**ON-SITE SEWAGE DISPOSAL SYSTEM
HOWARD COUNTY HEALTH DEPARTMENT
BUREAU OF ENVIRONMENTAL HEALTH**

SUBDIVISION: Dustin Property LOT NUMBER: 1

ADDRESS: 8076 Hunterbrooke Lane PROPERTY OWNER: James Berndt

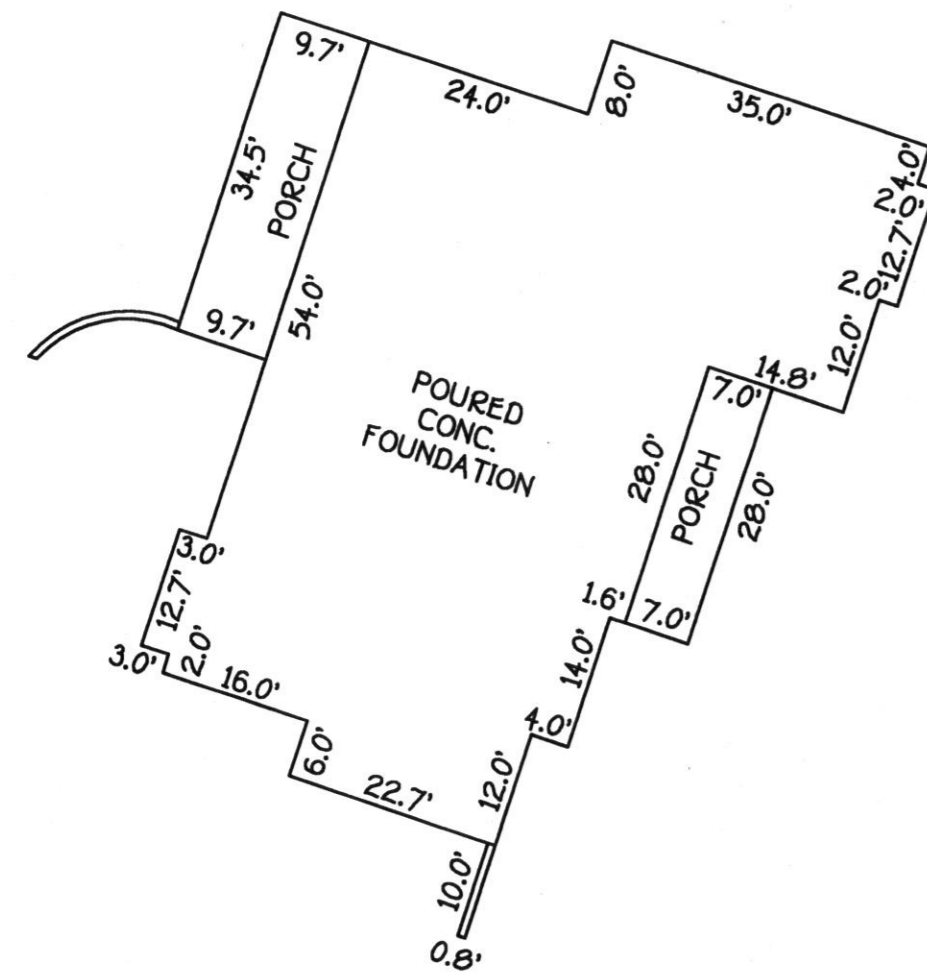
PRE-CONSTRUCTION
 7/29/09 Trench specs, changed to conserve area. Large tree in upper corner of

easement to be removed. Keep tank close to easement to limit cover from fill that will probably be put around house. Install a 55', 72' and 85' trench on contour in the highest part of the easement area. (BB)
 INSTALLATION
 7/31/09 System finished. O.K. to backfill. (BB)

LINEAR FEET OF TRENCH REQUIRED: ~~12~~ 212' 55', 72' + 85'
